**FLAGLER COUNTY PLANNING AND DEVELOPMENT BOARD  
PUBLIC HEARING/AGENDA ITEM NO. 9**

**SUBJECT: QUASI-JUDICIAL** – Project 2024070056– request for a Modification to an approved Special Exception (Order No. 3024) for an Overflow Parking Lot in the R/C (Residential/Limited Commercial) District at 93 and 95 Sanchez Avenue, and 5358 and 5364 North Oceanshore Boulevard. Parcel numbers: 40-10-31-0010-00020-0030, -0040, -0200, and -0210; 20,000 square feet (0.4591 acres). Owner: A1A 5384, LLC/Applicant: Jay W. Livingston, Esq., Livingston & Sword, P.A. (AR No. 5052).

**PROJECT 2024070056**  
**SPECIAL EXCEPTION IN THE R/C DISTRICT**  
**A1A 5384, LLC**  
**TECHNICAL STAFF REPORT**

**FINAL SITE & LANDSCAPE PLAN**

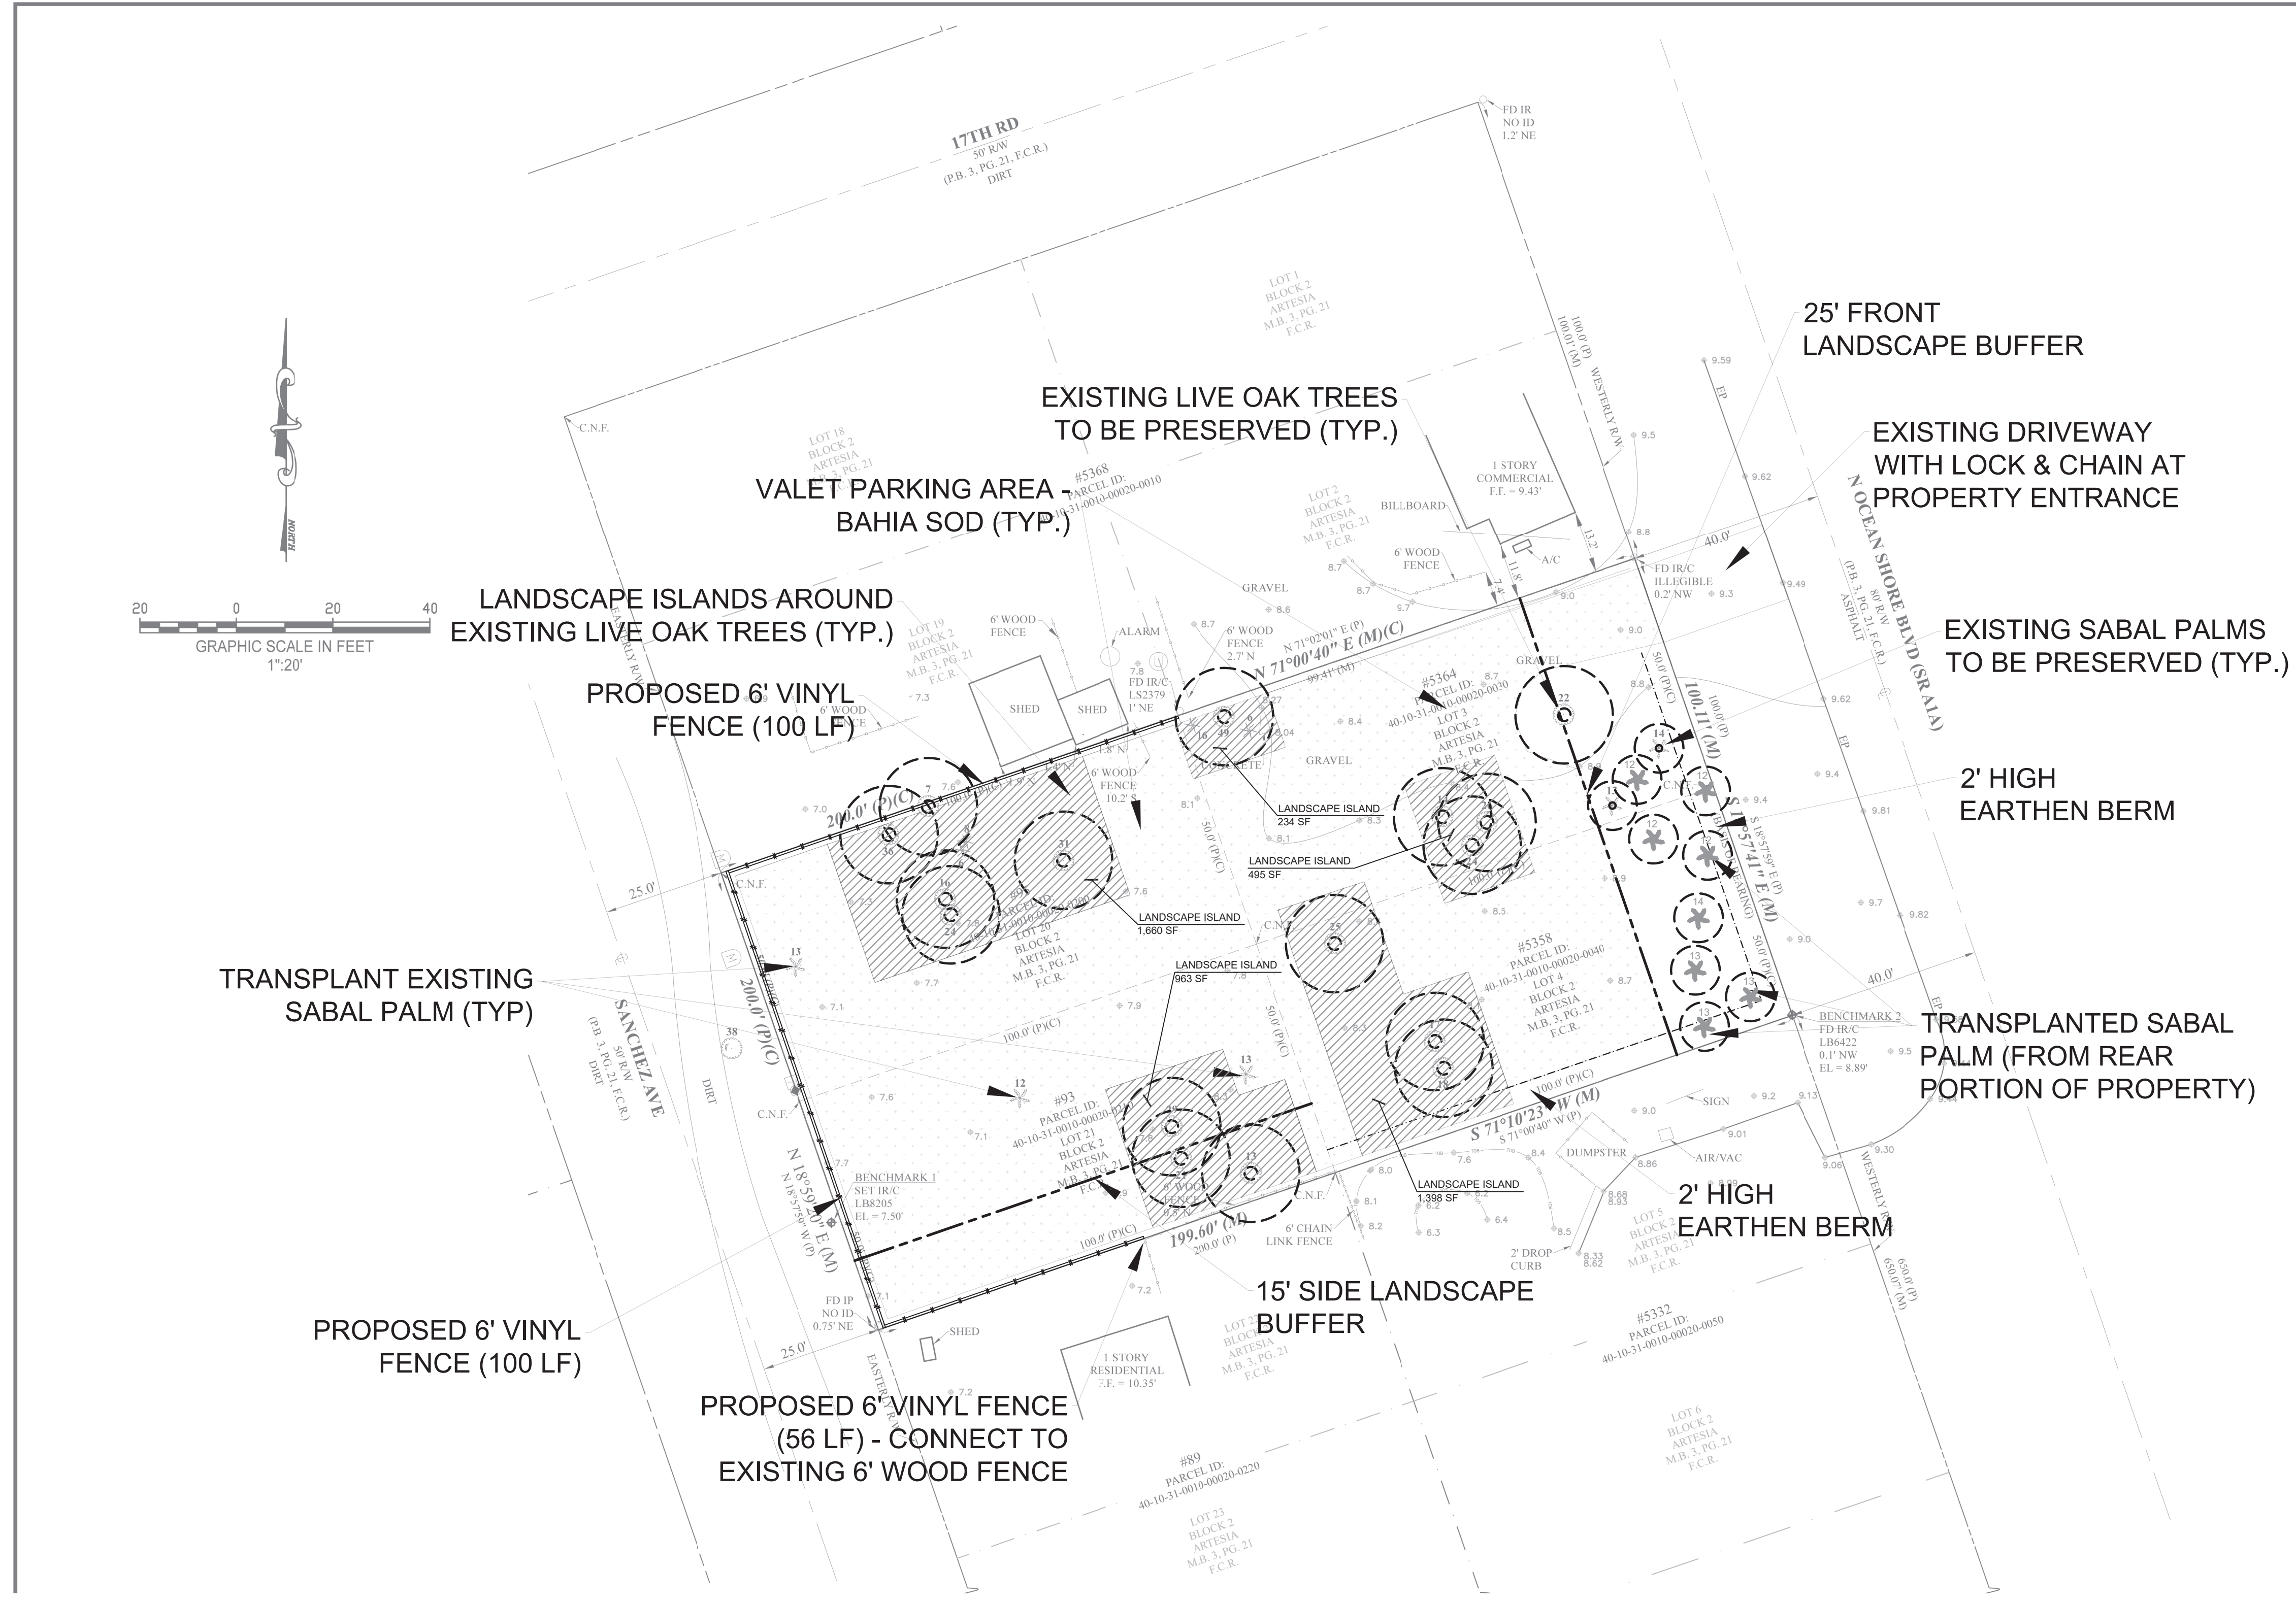
1. Is this to be an extension of the existing special exception for the Bronx House Pizza property?
2. What, if any, signage will be provided?
3. Show the the amount, location, and dimensions of parking spaces.
4. What material is proposed for the parking?
5. Show the vehicular circulation through the property.
6. Address the 9 special exception criteria in LDC Sec. 3.07.03 F, specifically:
  1. How will pedestrian access/safety be ensured? How are predestrians getting from the subject propoerty to the restaurant property?
  2. How will efects on neighboring properties be minimized?
  6. Will lighting be provided?
7. When more details are determined, please provide a site data table with areas and impervious calculations.
8. How will or won't parking be monitored?

- 1.The location and size of proposed improvements shall be shown on the site plan.
- 2.The material for the parking lot should be described in detail. If to remain natural the natural state of the lot should be described.
- 3.Demonstrate that the site will have safe pedestrian passage to and from the Bronx House site.
- 4.Provide a site data table that includes parking calculations.
- 5.Parking spaces shall be shown and detailed on the site plan.

7. When more details are determined, please provide a site data table with areas and impervious calculations.

**RESPONSE:** The parking lot will be maintained in its natural state with the area to be used for parking seeded with Bahia grass. This will avoid the placement of fill dirt and impervious surfaces, which would likely require stormwater management and significant clearing of the lot. Keeping the lot in its natural state with only minimal clearing to provide for a grassed parking area will allow the landowner to maximize the number of preserved trees and protect the integrity of A1A as a Scenic Byway.

**RESPONSE: Applicable site data with relevant area calculations is provided on the revised conceptual plan. No additional impervious surfaces are proposed except the possibility of a de minimis addition if the County or FDOT requires the driveway apron to be paved.**

**RESPONSE: The parking lot is to remain natural. The interior areas outside of any landscape buffer will be seeded with Bahia grass. The conceptual plan has been updated to specify the proposed surface for the parking area.**

Diagram 1: Projected Traffic Flow Diagram

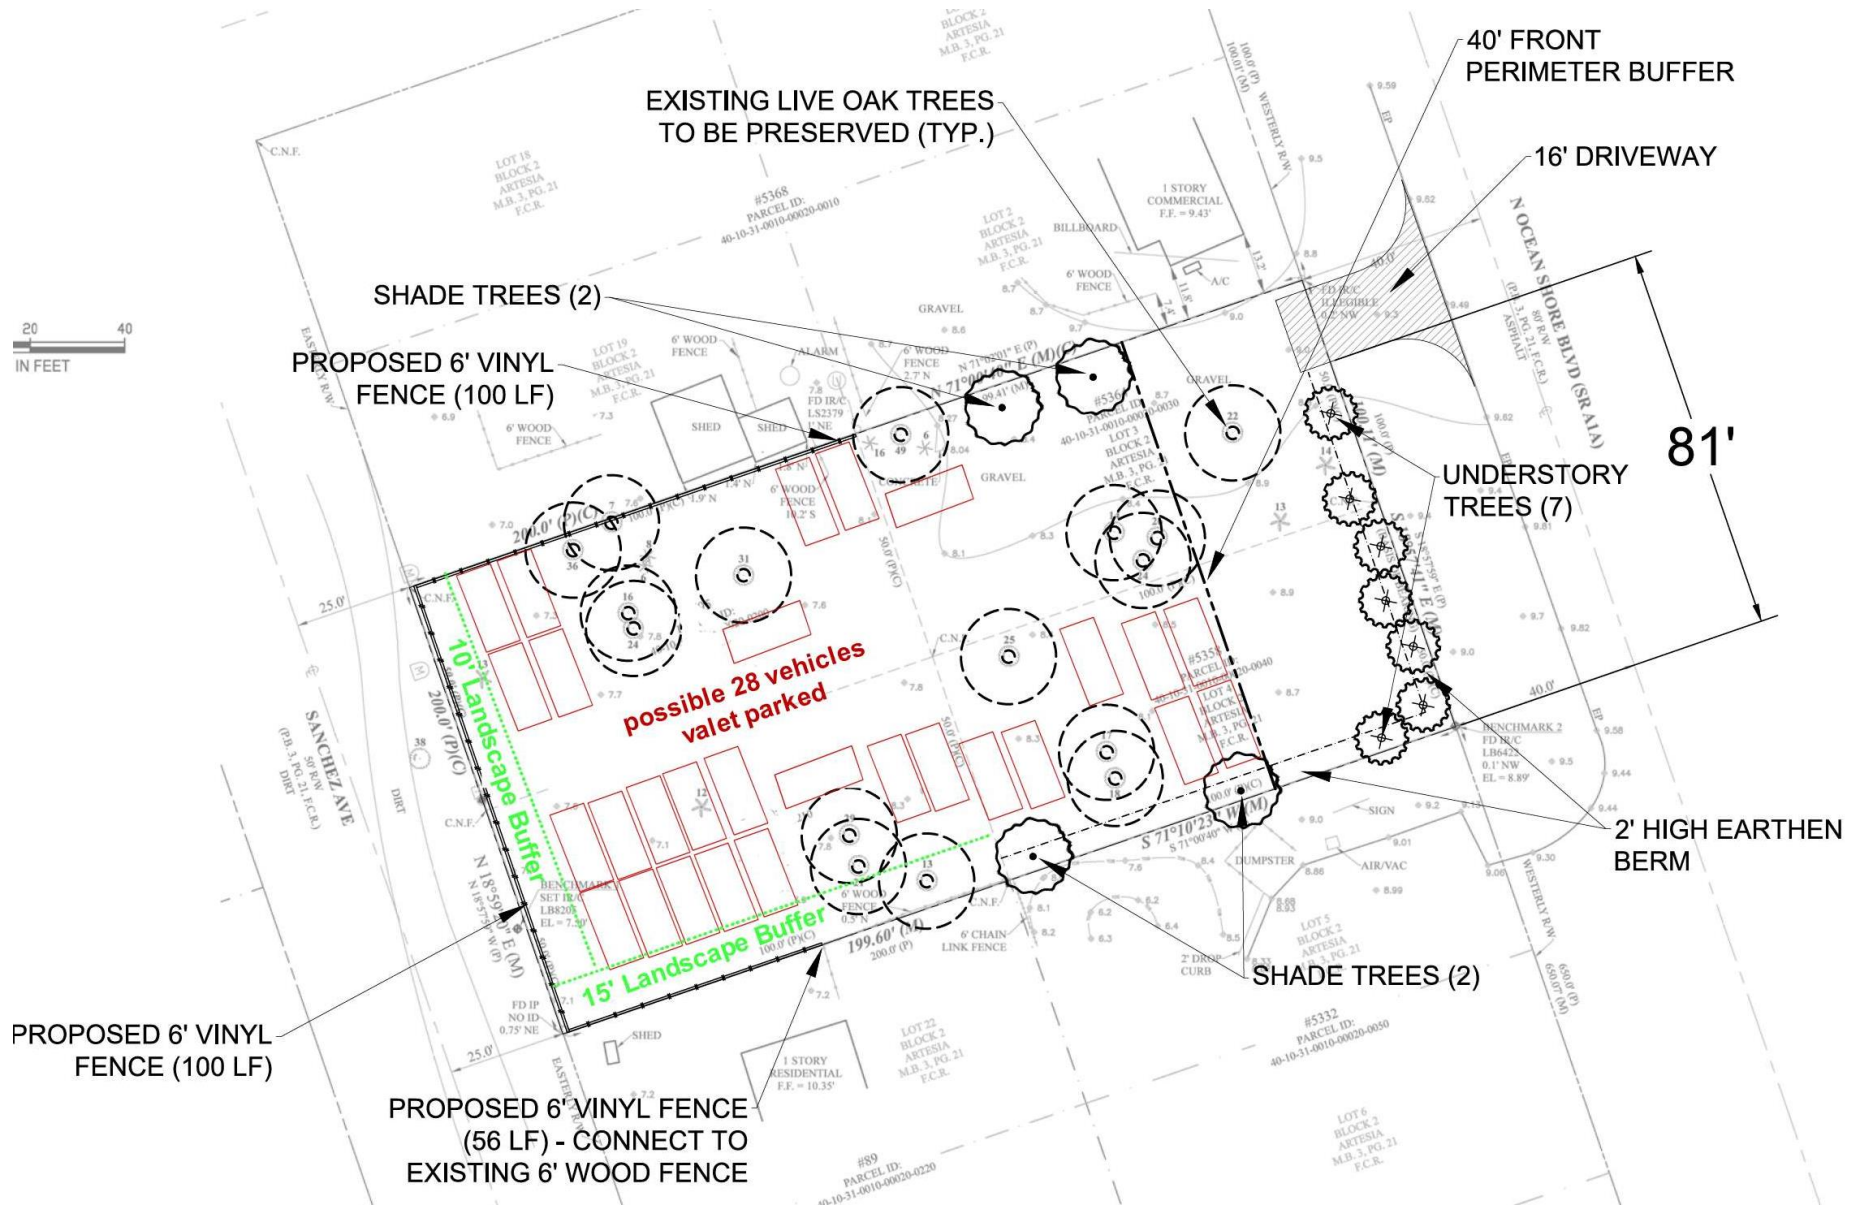
1. Ingress to and egress from the property shall provide for automotive and pedestrian safety and convenience, shall not unduly interfere with traffic flow and control, and shall provide access in case of fire or catastrophe. **This operation will interfere with traffic flow.**
